Report
on
Technical Review
Dalby, Chinchilla, Miles, Jandowae, Wandoan and
Tara Flood Reports

31 March 2014

Technical Review
Draft 2013 Riverine Flood Study
Progress Update

Our Ref: 1431-16-78-v01

Figure 1a. Dalby 1 in 100 AEP (2012 -2014) with Comparison Points

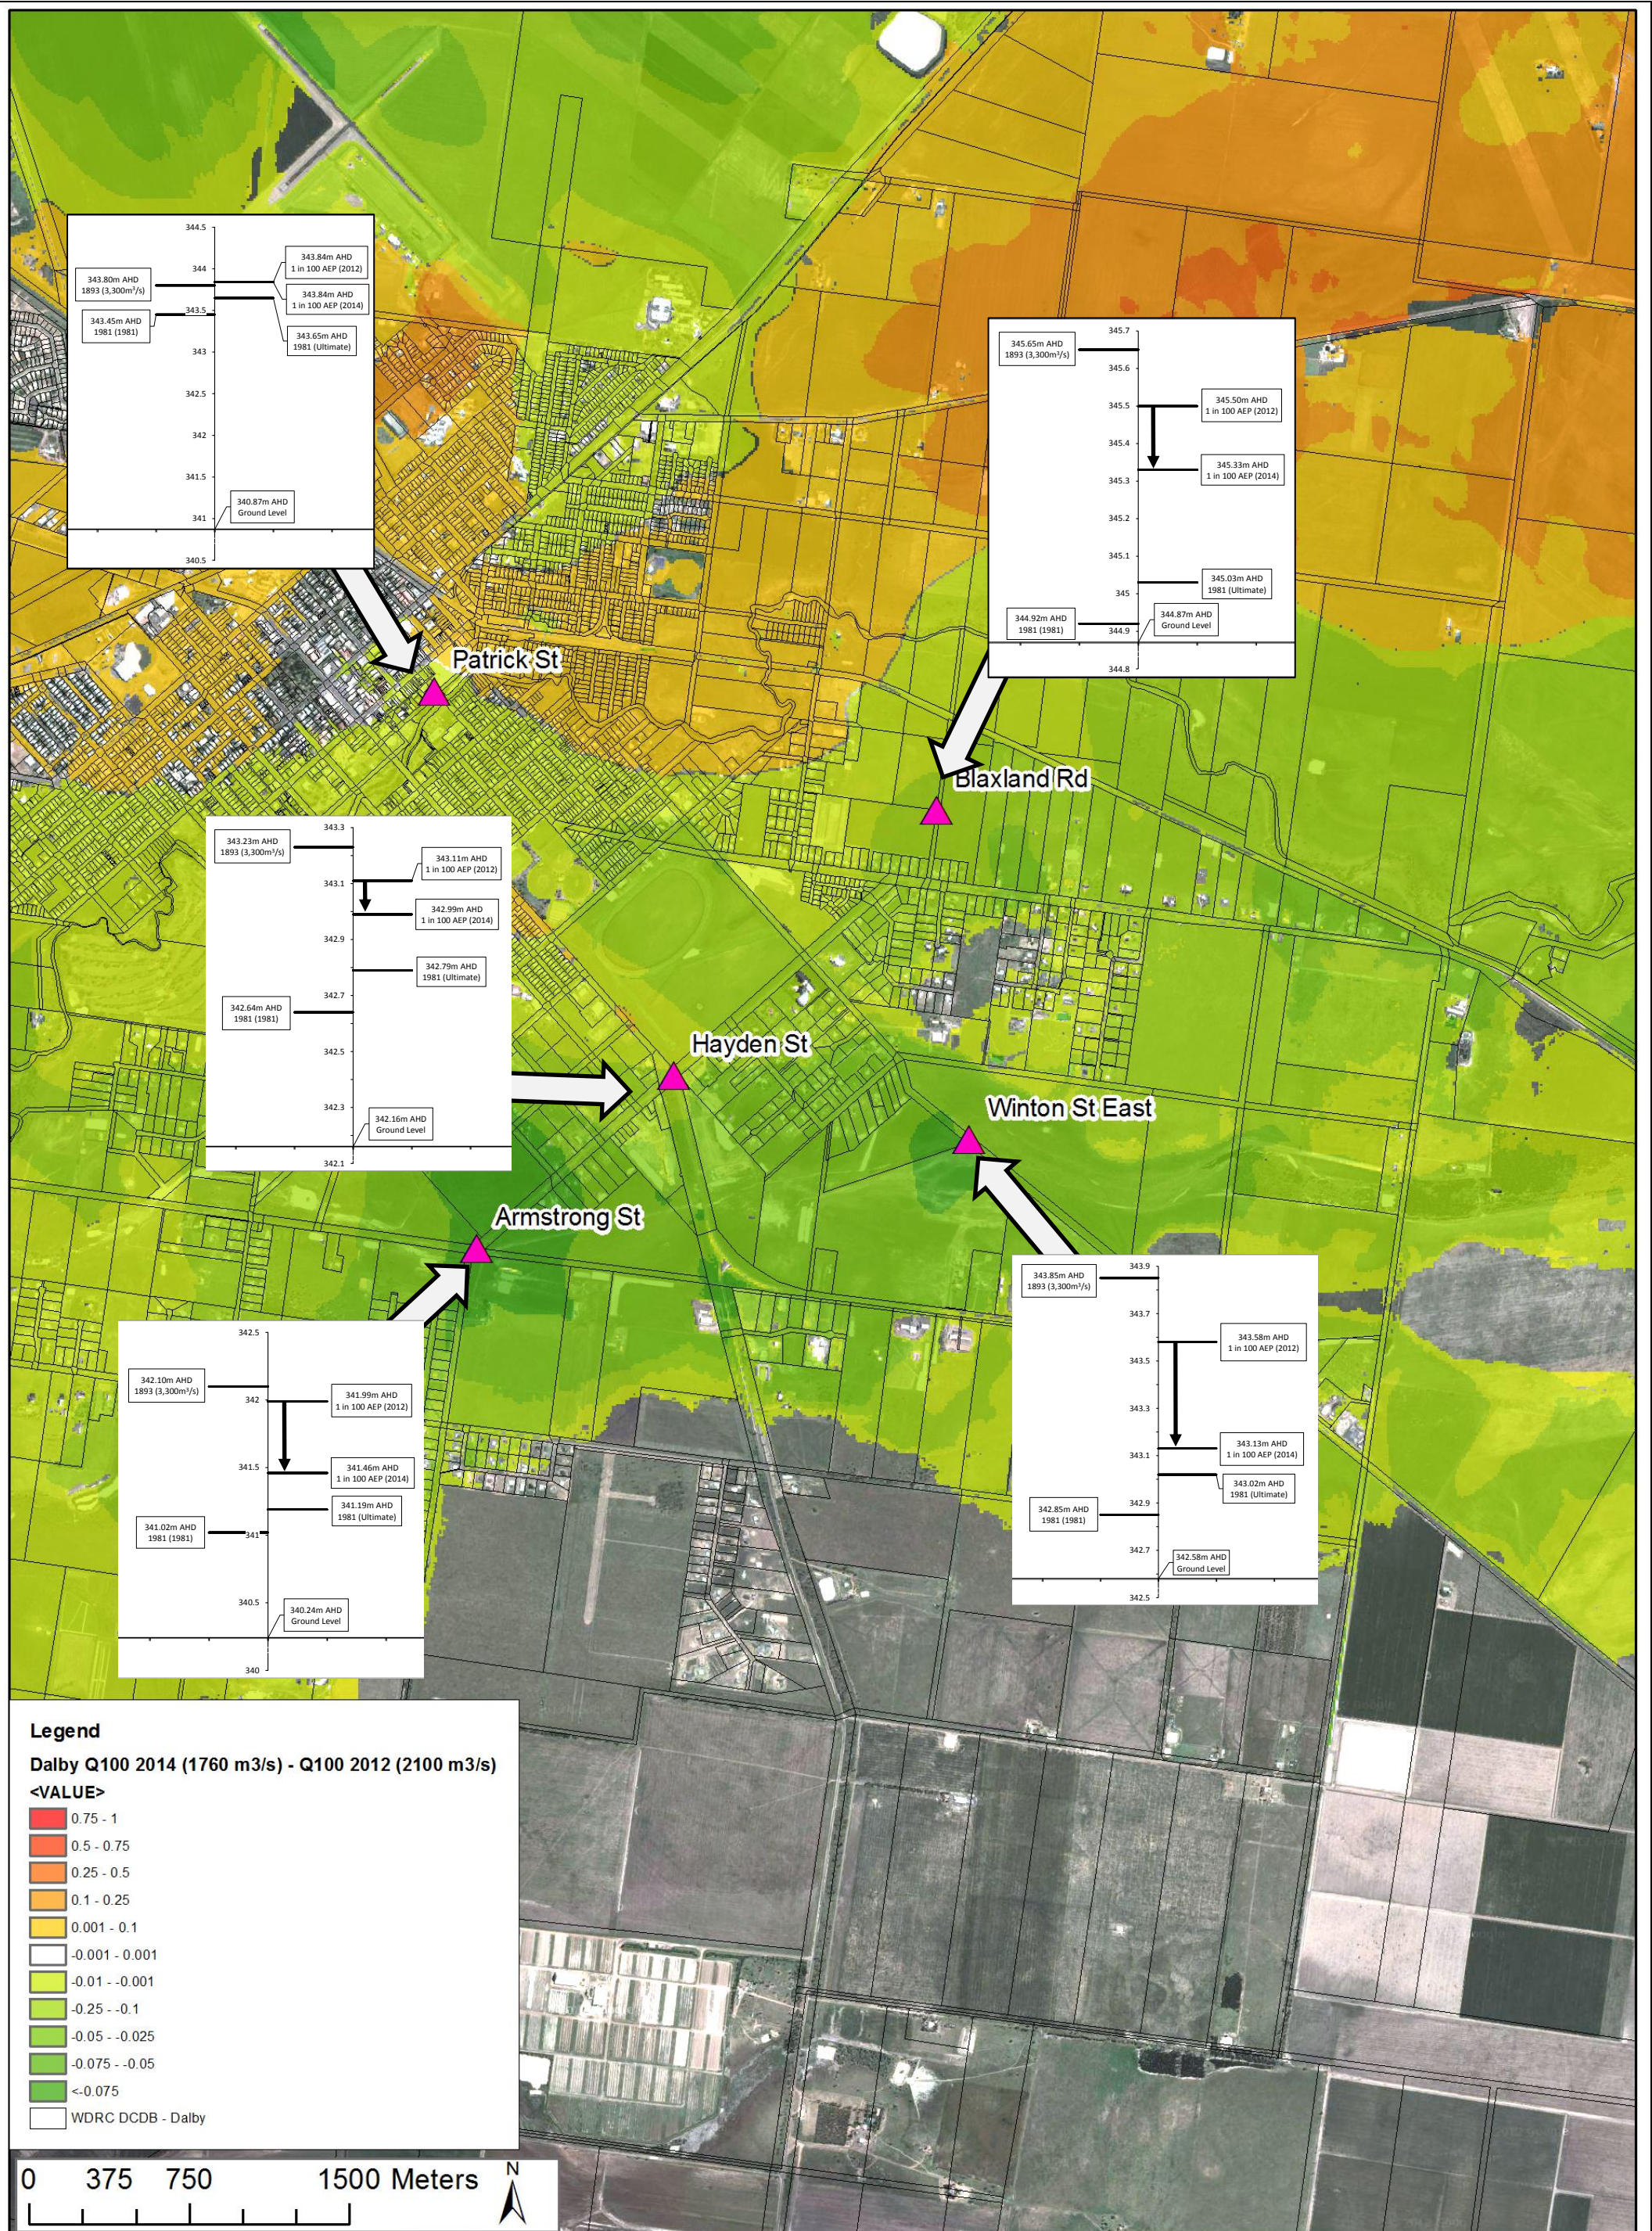
- i) ***Given the reduced Q100 discharge at Dalby, why has the predicted flood level (at Patrick Street for example) increased? Note this discussion should not just be restricted to Patrick Street but other key locations (with substantial increase in water levels) as well.***

- 1) **Historical data – need to include both together with simple mud maps of changing design levels wrt historical levels**

The predicted flood surface as reported in the March 2014 report is in fact slightly lower (0.01m) in the vicinity of the Patrick St gauge than that reported in the Nov 2012 report. There are two reasons why the comparison between flood surfaces and reported levels is complex. These are firstly, that the reporting locations (for “Patrick St”) have changed between Nov 2012 and March 2014 reports and secondly the change in flow splits based on the additional modelling at Mocatta’s corner. These are discussed in more detail below:

- The Nov 2012 report presented a Q100 (2,100m³/s) level of 343.70m AHD level at the Patrick St TM gauge.
- The March 2014 report presents a Q100 (1,760m³/s) level of 343.80m AHD at the Patrick St Bridge gauge. The corresponding Q100 level at the Patrick St TM gauge is 343.69m AHD (this was not presented in the report). The flood surface as reported in the March 2014 report is approximately 0.01m lower in the vicinity of the Patrick St gauge when compared to the flood surface as reported in the Nov 2012 report.

The additional modelling undertaken for the Mocatta's corner area has resulted in a change in flow distribution upstream of Dalby. This is discussed in section 10.2.1 in the report. Previously a flow of 28% flowing to the west and 72% flowing to the south was adopted for all flows. Table 10.2 and Appendix I present the results of the additional investigations which have results in adjusted flow splits (varying across the range of design events considered) used in the modelling reported in the March 2014 report.

The effect of this adjusted flow split has been to increase the proportion of flow flowing through the CBD. There is a corresponding decrease in the proportion of flow flowing over the railway line and to the southern flowpath.

When considering the drop in Q100 flow from 2,100m³/s to 1,760m³/s, for the Patrick St Bridge vicinity, an increase in the proportion of flows reaching the CBD area has counteracted somewhat the reduction in overall flow. For the southern overland flow path, the reduction in both overall Q100 flow and the proportion of flow has meant drops in predicted Q100 level of up to 0.3m.

Attached is a figure presenting the difference in predicted water surface level for the Q100 event as reported in Nov 2012 and as reported in March 2014. The areas shown as yellow/red are areas where levels have increased (in the March 2014 report, compared to the Nov 2012 report). This is due to the change in flow distribution from Mocatta's corner "overshadowing" the decrease in the overall Q100 flow. The areas shaded green are areas

where there are reductions in level caused by both the change in flow distribution from Mocatta's corner and the reduction in the overall Q100 flow.

For selected points in the catchment, Figures 1a and 1b a comparison of:

- 1981 levels as observed,
- Levels that could be expected if the 1981 flood was experienced with ultimate levels of development as per the planning scheme,
- The study team's best estimate of 1893 levels (corresponding to a discharge of 3,300m³/s)
- The 1 in 100 AEP event levels as presented in the November 2012 report,
- The 1 in 100 AEP event levels as presented in the March 2014 (this current) report,

Figure 1a presents these points superimposed on a map showing the difference between the Nov 2012 1 in 100 AEP flood surface and the March 2014 1 in 100 AEP flood surface.
